SAFETY RECALL BULLETIN

NHTSA RECALL 23V373

AUTOCAR, LLC SAFETY RECALL ACX-2306

Autocar, LLC has determined that certain ACX models may have improperly assembled right door latches.

Figure 3, Incorrect Orientation

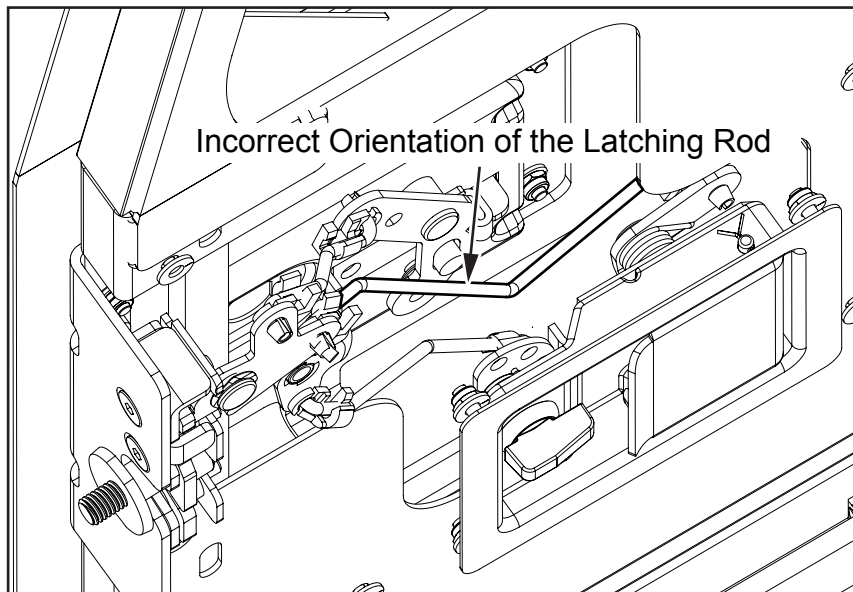
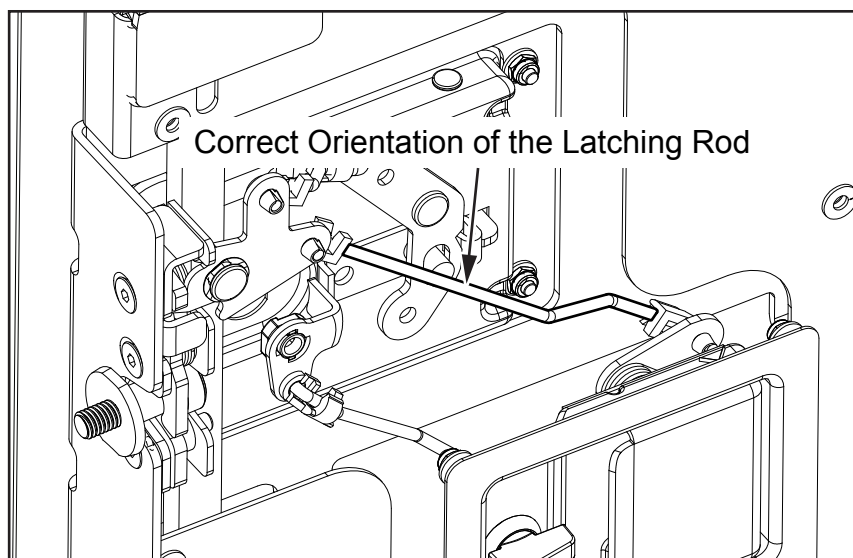
4. Locate the latching rod and verify its orientation. If the orientation of the latching rod is as shown in Figure 3, the installation is incorrect. Remove the latching rod and reinstall in the correct orientation as shown in Figure 4 (see *Figures 3 and 4*).

Figure 4, Correct Orientation
